RESPONSE TO REQUEST FOR ADDITIONAL INFORMATION

APR1400 Design Certification

RAI No.: 32-7946
SRP Section: 08.03.01 – AC Power Systems (Onsite)
Application Section: 08.03.01
Date of RAI Issued: 06/16/2015

Question No. 08.03.01-1

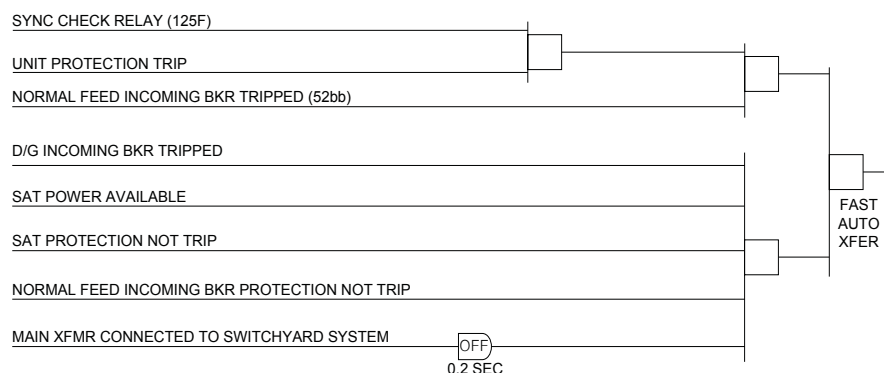
1. How a loss of voltage at any one of the Class 1E buses of one division initiates an automatic fast transfer of the offsite power source to an unaffected bus of another division by switching the affected bus to an unaffected SAT
2. How the automatic transfer to a faulted bus will be prevented

3. For a potential failure in the fast transfer scheme (such as failure of a circuit breaker, or failure of control power), address the vulnerability of the scheme so that the fast transfer scheme failure does not affect the capability of the Class 1E emergency diesel generators (EDG) to perform their safety function of supplying electrical power to the Class 1E emergency buses in a loss of voltage condition
4. Discuss how the automatic fast transfer prevents a bus transfer to an out-of-phase source, and discuss the sync-check logic scheme

A loss of voltage at any Class 1E bus of one division does not initiate the automatic fast transfer of the offsite power source. The automatic fast transfer is initiated only in a case when there is a unit protection trip at the normal preferred power supply (PPS) circuit.

The procedure of the automatic fast transfer is as follows:

- The unit protection trip due to failure of the unit auxiliary transformers (UATs), isolated phase bus (IPB), generator circuit breaker (GCB), main transformer (MT), or switchyard circuit breakers gives trip signals to the normal feed incoming breakers of all MV buses of both divisions and close signals to the alternate feed incoming breakers of the MV buses.
- For each bus, closing of the alternate feed incoming breaker is permitted by output of the synchro-check relay for fast transfer and the open status of the normal feed incoming breaker and EDG feeder breaker.

For more information, a simplified control logic diagram for the automatic fast transfer is provided below:

If the fast transfer is blocked by the synchro-check relay (125F) output, a residual transfer will be performed automatically when the condition is met.
